## Product / Process Change Notification (PCN)

**PCN #:** PCN\_IndExB\_20210401  
**Affected Series:** WE-ExB-Series  
 744844xxx S17100062

**PCN Date:** January 04, 2021  
**Effective Date:** April 01, 2021

### Spacer drawing for WE-ExB Series

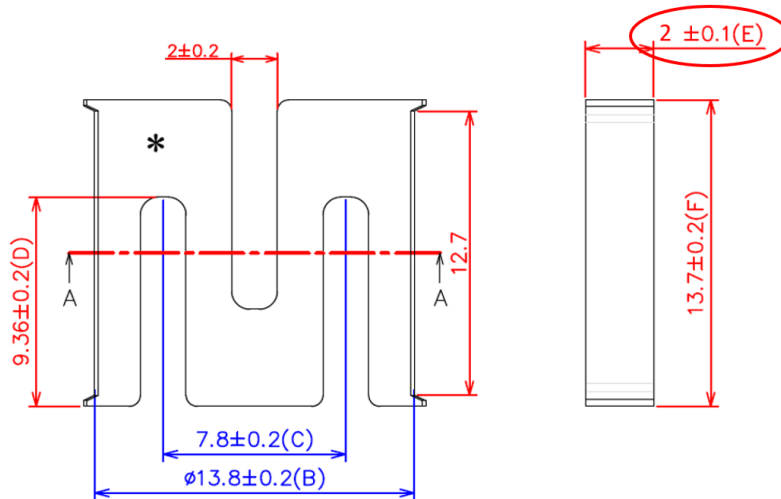
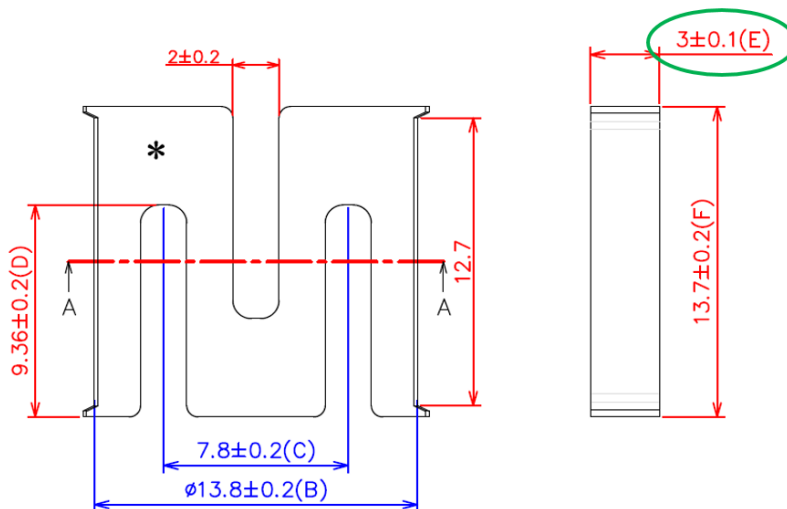
To assure assembling processability, Würth Elektronik will change the spacer thickness from currently 2 mm to 3 mm. For detailed information, refer to following drawings.
